UNITED STATES
DEPARTMENT OF THE INTERIOR
BUREAU OF LAND MANAGEMENTFORM APPROVED
OMB NO. 1004-0135
Expires: July 31, 2010**SUNDRY NOTICES AND REPORTS ON WELLS**
*Do not use this form for proposals to drill or to re-enter an abandoned well. Use form 3160-3 (APD) for such proposals.*5. Lease Serial No.
NMSF078903

GALLEGOS CANYON UNIT 57

Re: Permanent Abandonment
Well: Gallegos Canyon Unit #57

CONDITIONS OF APPROVAL

Proposed P&A

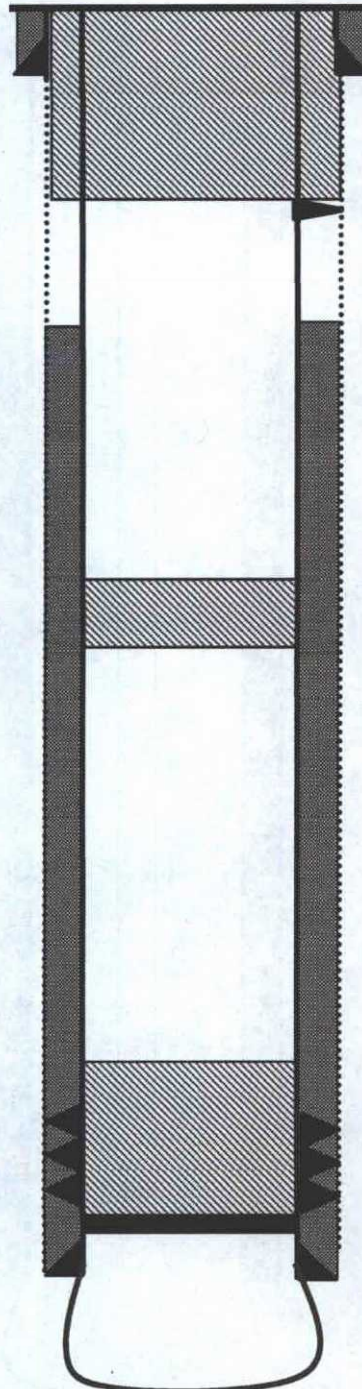
1. Plugging operations authorized are subject to the attached "General Requirements for Permanent Abandonment of Wells on Federal and Indian Lease."
2. Farmington Office is to be notified at least 24 hours before the plugging operations commence (505) 564-7750.
3. The following modifications to your plugging program are to be made:
 - a) Set plug #2 (1395-1295) ft. to cover the Fruitland top. BLM picks top of Fruitland at 1345 ft.
 - b) Set plug #3 (559-0) ft. to cover the Ojo Alamo interval, Kirtland top, and surface casing shoe. BLM picks top of Ojo Alamo at 405 ft. BLM picks top of Kirtland at 509 ft.

Operator will run a CBL to verify cement top. Submit the electronic copy of the log for verification to the following addresses: jwsavage@blm.gov tsalyers@blm.gov Brandon.Powell@state.nm.us

You are also required to place cement excesses per 4.2 and 4.4 of the attached General Requirements.
